POST OCCUPANCY EVALUATION
CHINLE HOSPITAL

Division of Health Facilities Planning
ORM/OM/OASH

FORWARD

M-5 Solar Panels, Incinerator, and Bottle Gas Storage

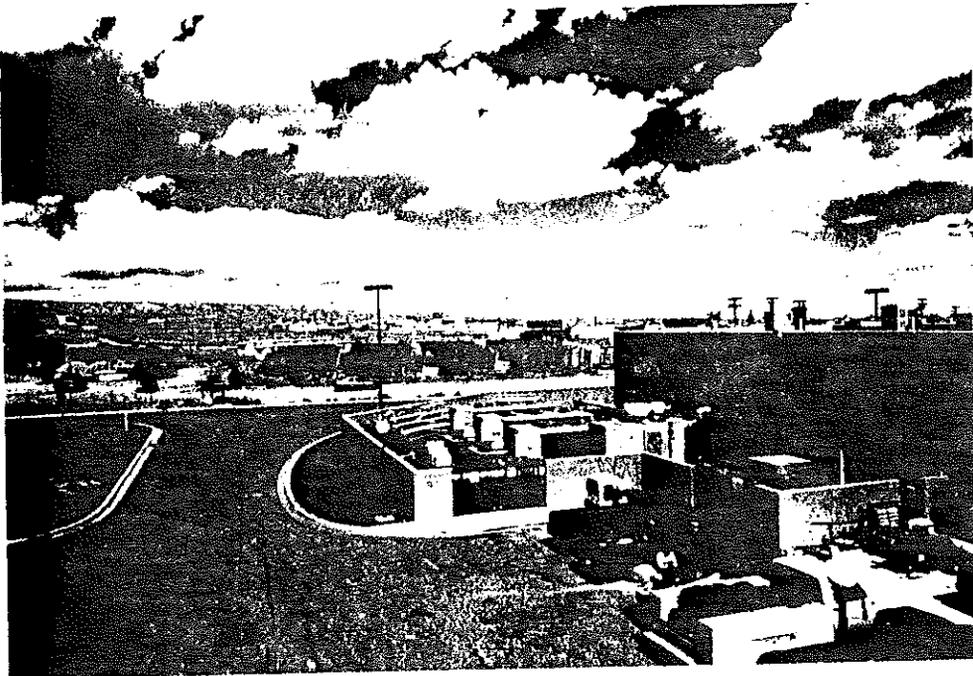
- g. Incinerator - The incinerator is installed behind the building in an inclosure as shown in photo M-5. There is a need for a storage unit to house the excessive waste flow and left over material at days end.

M-8 Roof and Walkways

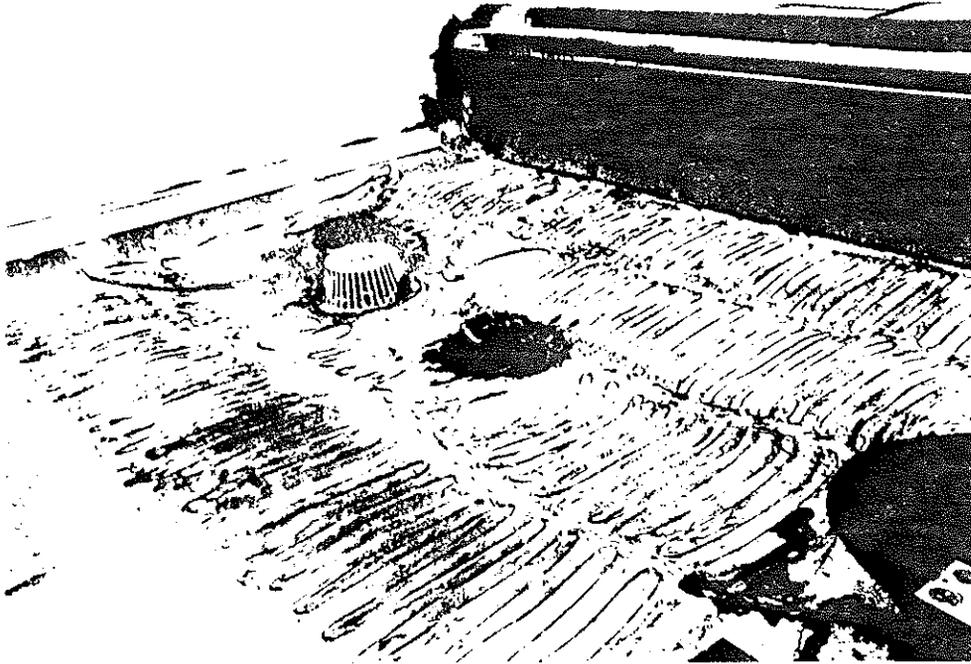
- 2) The roof is covered by roll roofing material with other material laid on it for maintenance walkways. Photo M-8 gives a general idea of the roof walkways and equipment. The light area in the photo is the heat tape areas around a roof drain as shown in photo M-9. Freezing of precipitation on the roof next to drains is a serious problem in this climate.

- c. The roof mounted equipment is mostly fans as can be seen in photo M-8. In colder climates, all roof mounted equipment should be enclosed to facilitate maintenance and repair. There are 32 exhaust fans and 19 relief vents installed on the roof, all requiring maintenance.
